SOLICITATION AMENDMENT MODIFICATION DE L'INVITATION

Title - Sujet Traverse Trail Clearing & Grubbing	
Solicitation No. - N° de l'invitation EZ899-171514/A	Amendment No. - N° modif. 005
Client Reference No. - N° de référence du client	Date 2016-11-23
GETS Reference No. - N° de référence de SEAG PW-\$PWY-033-7889	
File No. - N° de dossier PWY-6-39165 (033)	CCC No./N° CCC - FMS No./N° VME
Solicitation Closes - L'invitation prend fin at - à 02:00 PM on - le 2016-12-01	
Time Zone Fuseau horaire Pacific Standard Time PST	
F.O.B. - F.A.B. Plant-Usine: <input type="checkbox"/> Destination: <input checked="" type="checkbox"/> Other-Autre: <input type="checkbox"/>	
Address Enquiries to: - Adresser toutes questions à: Siopongco, Philip PWY	Buyer Id - Id de l'acheteur pwy033
Telephone No. - N° de téléphone (604) 351-6139 ()	FAX No. - N° de FAX () -
Destination - of Goods, Services, and Construction: Destination - des biens, services et construction: PCA (Parks Canada) - Pacific Traverse Trail - Pacific Rim National Park - Tofino, BC

This Solicitation Amendment 005 is raised to provide clarification to Specifications and responses to questions not already answered (see Addendum 3) and revise

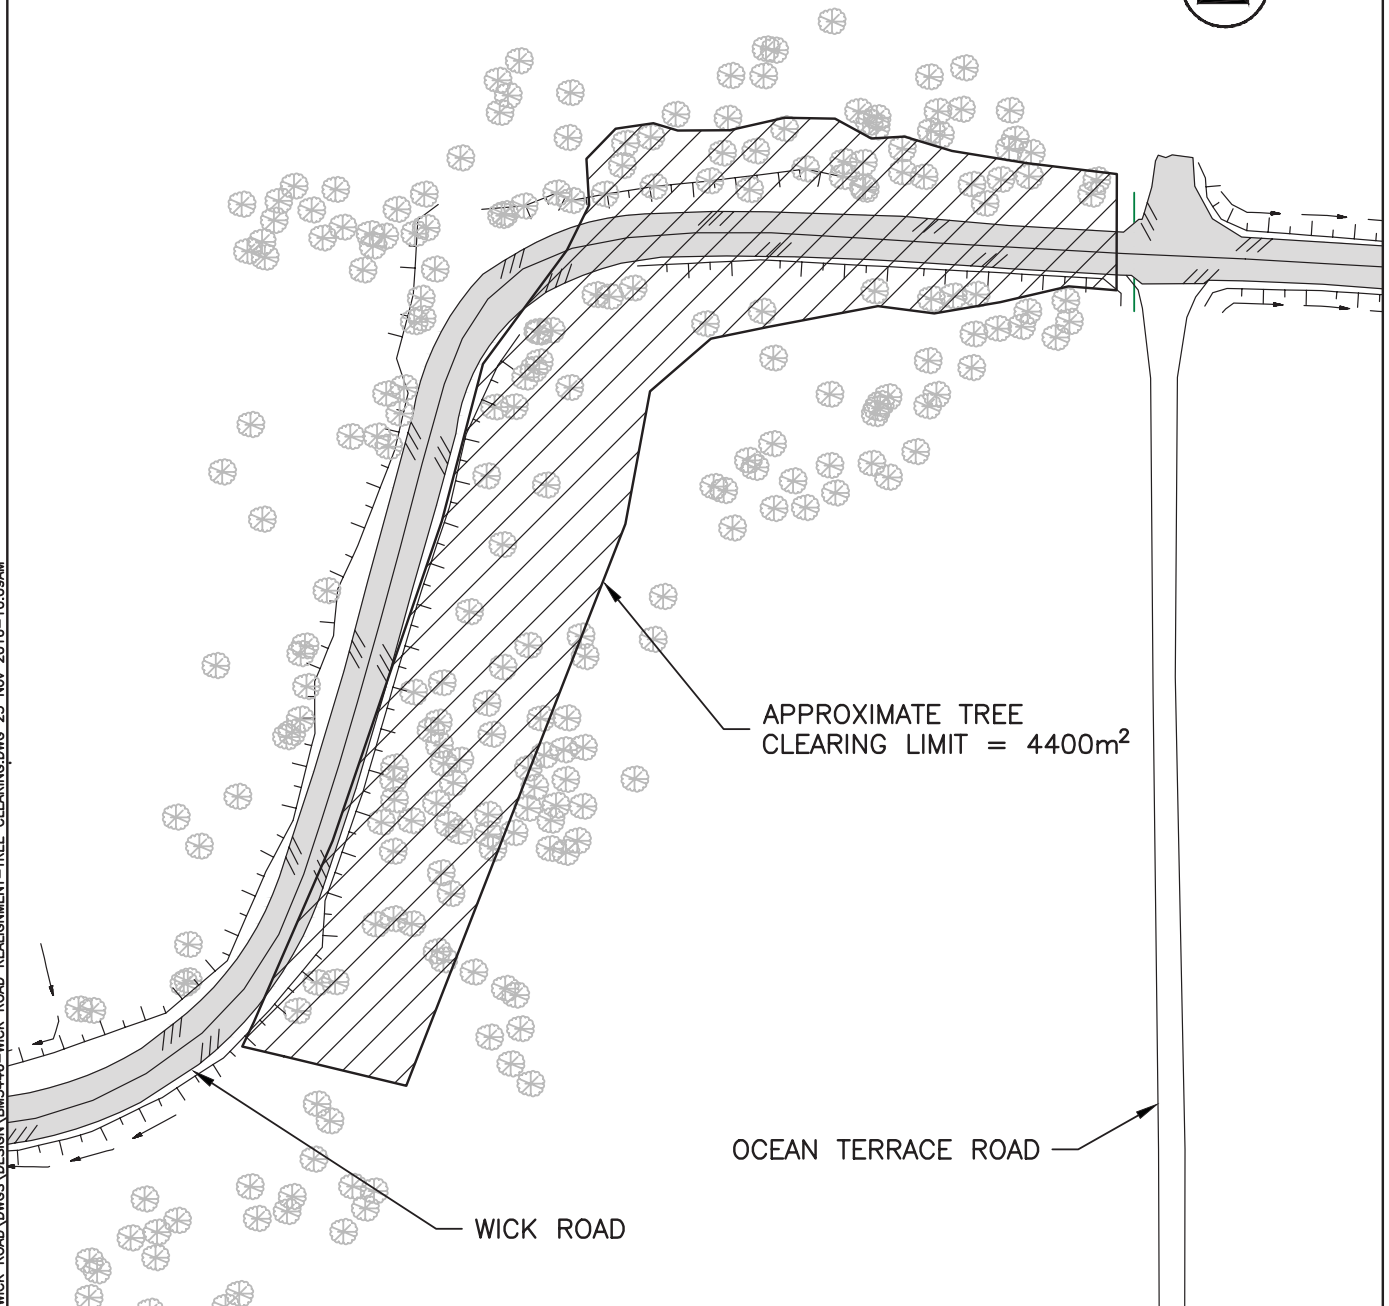
Additional clearing requirements are added for Wick Road as reflected on the Unit Price Table and identified on Figure 1 attached – Wick Road Tree Clearing.

31.1.4.b		Clearing for Wick Road	Hectare	0.44		
31.1.5		Clearing and disposal of danger trees along trail route	Each	300		
31.1.5A		Clearing and disposal of danger trees identified within the park boundary not on the trail route	Each	31
